Subject: Application for Permit Modification to the Section 404 Individual Permit and Section 401 Water Quality Certification for Construction of extension of NC 43 from south of NC 55 to north of US 17. Craven County. State Project No. 6.804857. TIP No. R-4463. Debit \$570 from WBS 35601.1.1.

The purpose of this letter is to request a modification to the US Army Corps of Engineers (USACE) Section 404 Individual Permit and NC Division of Water Quality (NCDWQ) Section 401 Water Quality Certification. The North Carolina Department of Transportation (NCDOT) is currently constructing the extension of NC 43 from NC 55 to US 17. The project, located west of New Bern in Craven County, is referred to as the NC 43 Connector (Bosch Boulevard) and is approximately 4.5 miles in length. A Section 404 Permit (Action ID 2007-02231-125) was issued on November 19, 2007 and Water Quality Certification issued (WQC No. 3673) on September 21, 2007. The project has been split into two sections, Section A and Section B. Section B has been let and construction has begun.

Summary of Changes

Table 1. Additional Permanent Jurisdictional Impacts for R-4463B

PROJECT REFERENCE NO. R-4463B	SHEET NO. 7
RAW SHEET NO.	
ROADWAY DESIGN ENGINEER	HYDRAULICS ENGINEER
PRELIMINARY PLANS DO NOT USE FOR CONSTRUCTION

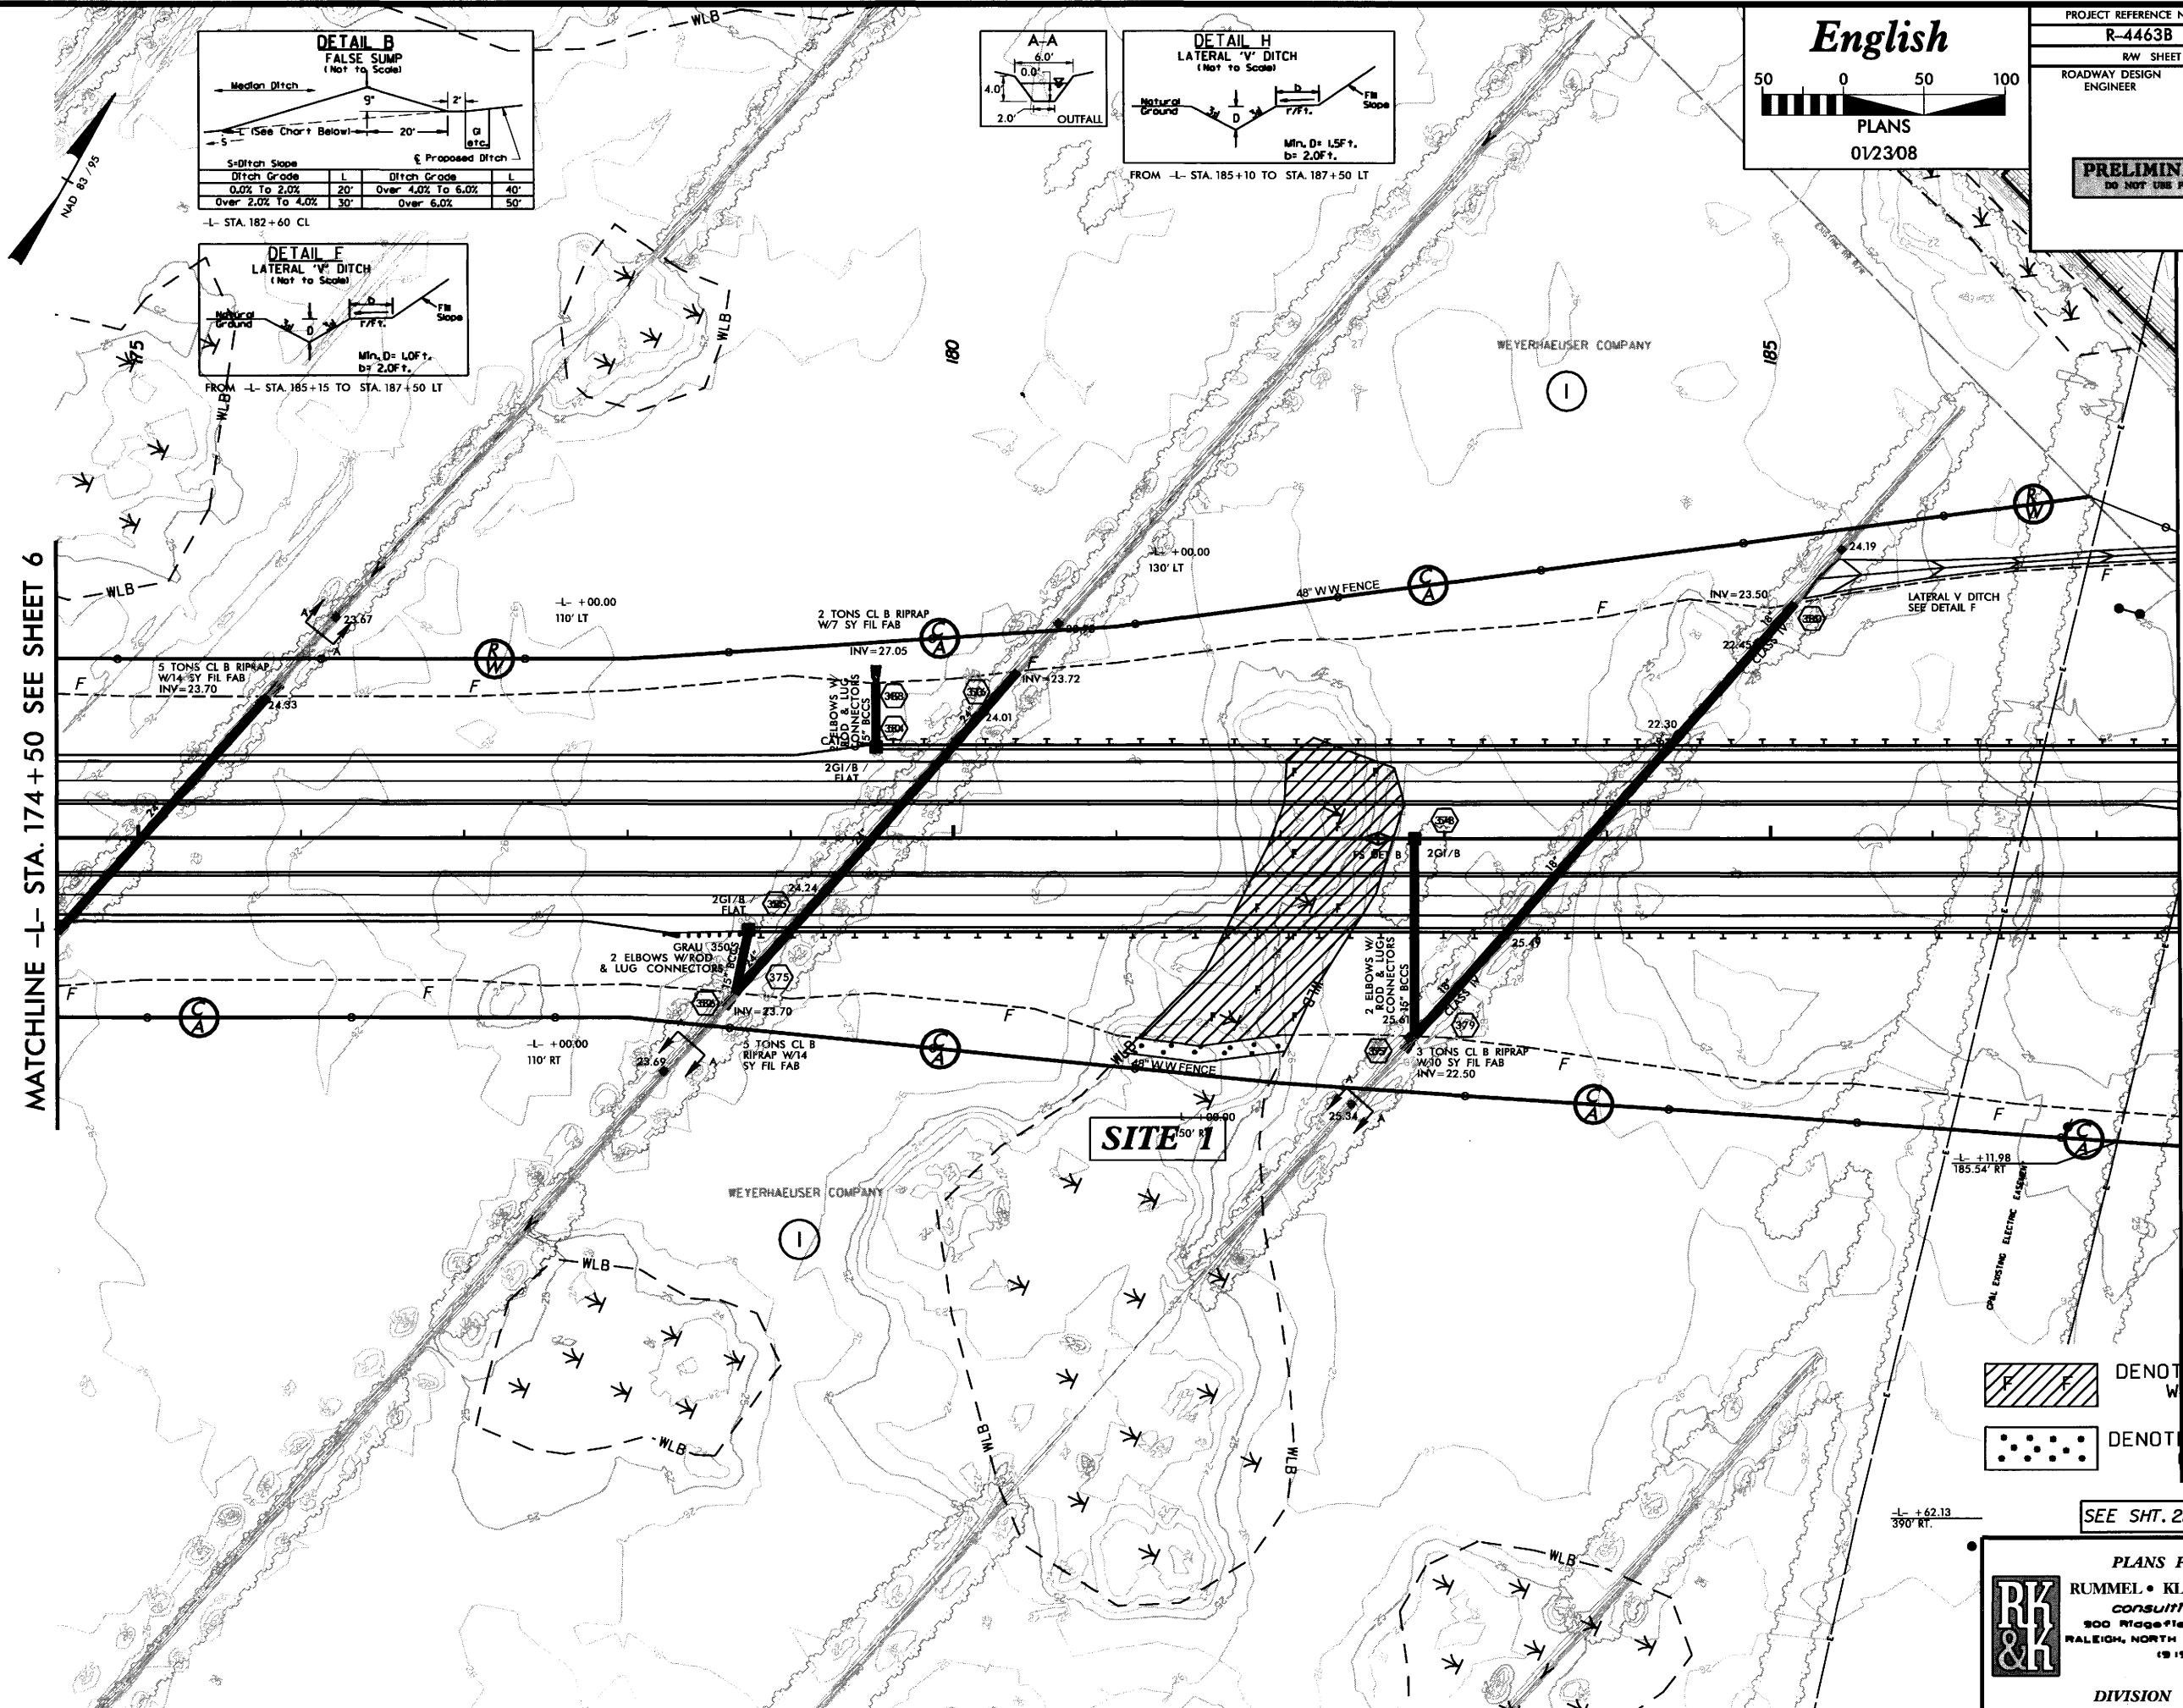
Changes to original design have been made due to enlarging the railroad bridge opening per the railroad’s request and adding a turn lane per a property owner request. The vertical profile change due to the railroad is –L- 171+50 – 205+58.15. The turn lane is –L- 225+00 – 232+00 LT.

Additional impacts to jurisdictional non-riverine wetlands are summarized in Table 1, as well as on sheets 7, 8, 10 and 11 of the attached revised permit drawings. Total additional permanent wetland impacts for the project are projected to be 0.13 acre. Temporary impacts to wetlands have not changed from what was authorized by the original permits.

February 4, 2008: Construction Revision #2: Proposed grade revised from -L- Sta. 171+50 to 205+73.15 for new horizontal and vertical clearance criteria for the Railroad.
 8/17/99
 04_08_15a1234
 gprulites\Permit Drawings\4463B_HYD_P1117.dgn

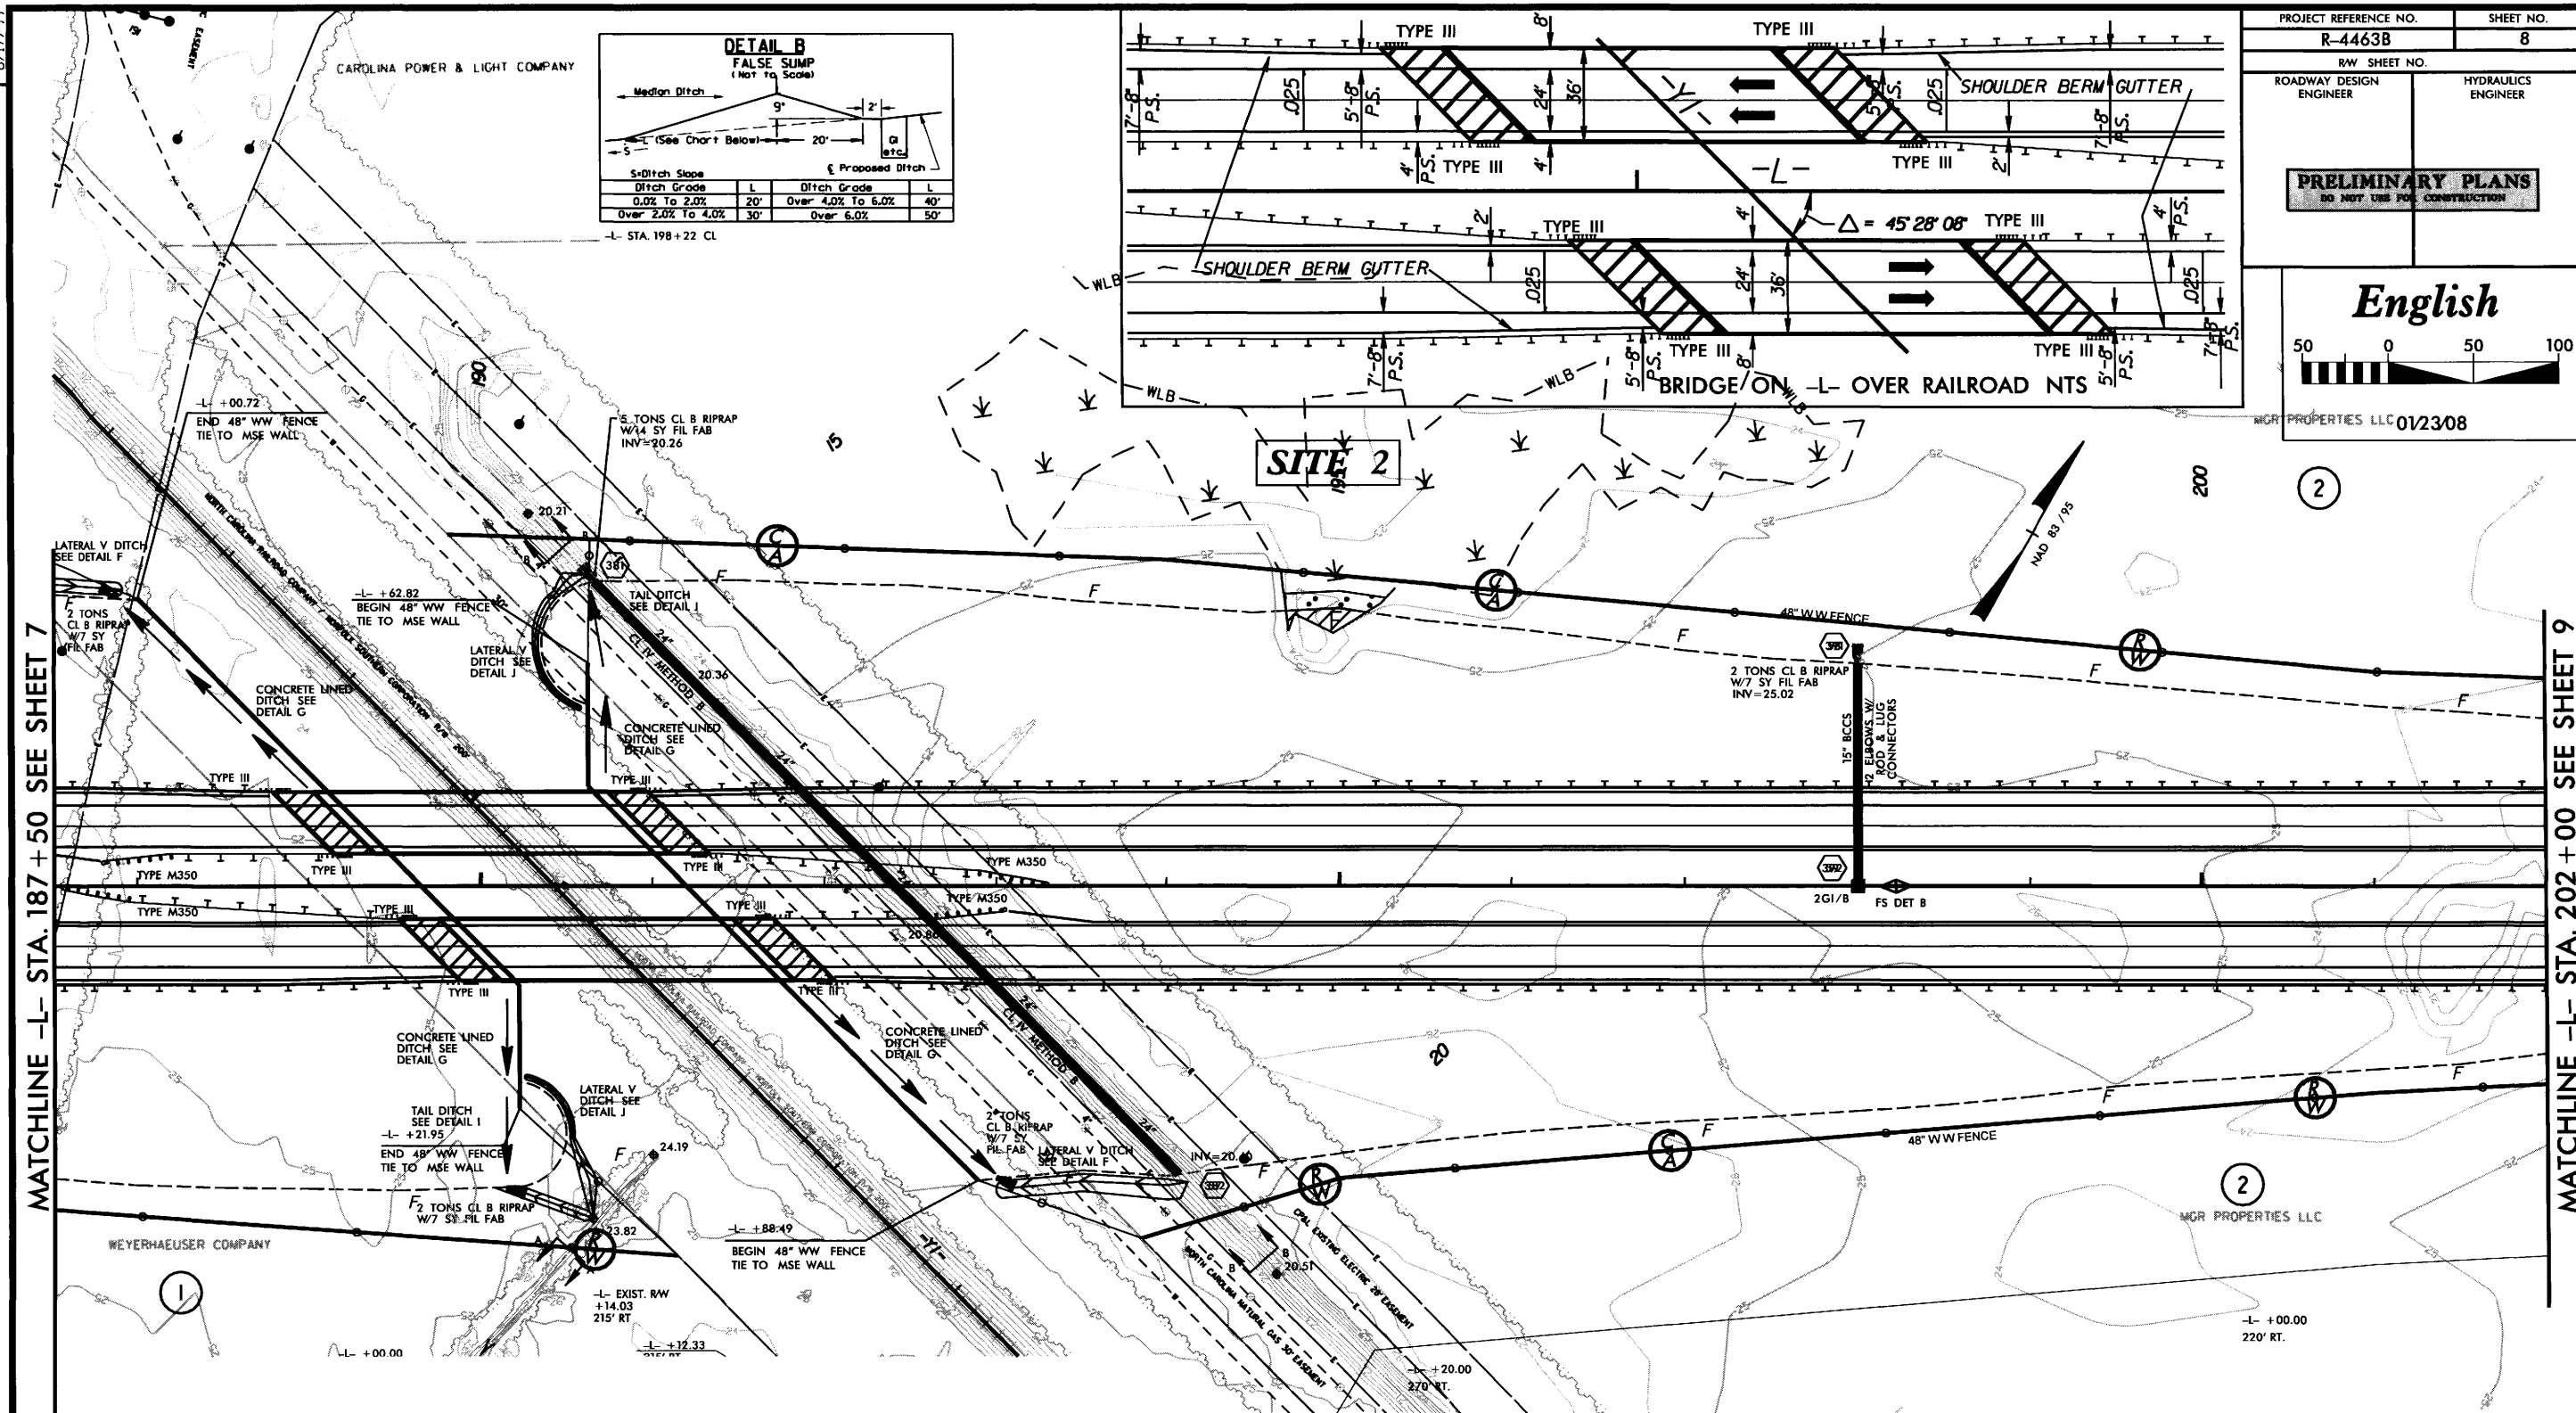
February 4, 2008; Construction Revision #2 - Proposed grade revised from -L- Sta. 171+50 to 205+73.15 for new horizontal and vertical clearance criteria for the railroad.
